MDI Return Loss Consensus proposal

Gerrit den Besten, Gitesh Bhagwat, Kambiz Vakilian, Mike Tu
NXP Semiconductors
Vienna, 15-18 July 2019

Consensus proposal

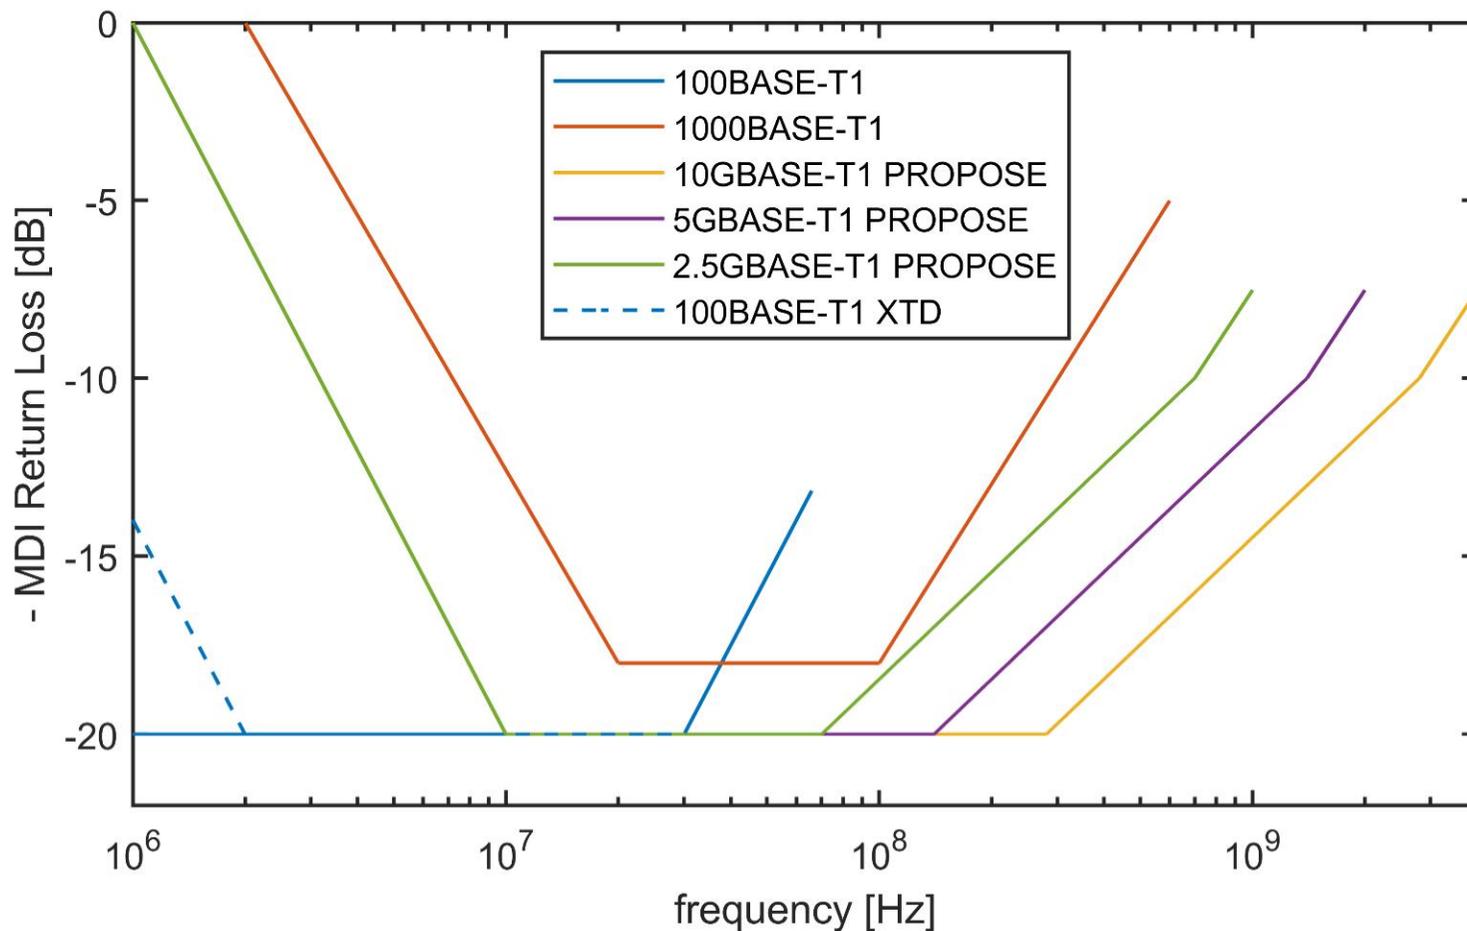
- ▶ 10dB/dec from 280S to 2800S MHz (10dB @ Nyquist)
- ▶ 16dB/dec from 2800S to Fmax (7.5dB @ Fmax)

Change formula 149-27 of draft D2.0 into:

- ▶ $20-20 \cdot \log_{10}(10/f)$ for $f=1-10$ MHz
- ▶ 20 for $f=10-280S$ MHz
- ▶ $20-10 \cdot \log_{10}(f/280S)$ for $f=280S-2800S$ MHz
- ▶ $10-16 \cdot \log_{10}(f/2800S)$ for $f=2800S-F_{\max}$ MHz
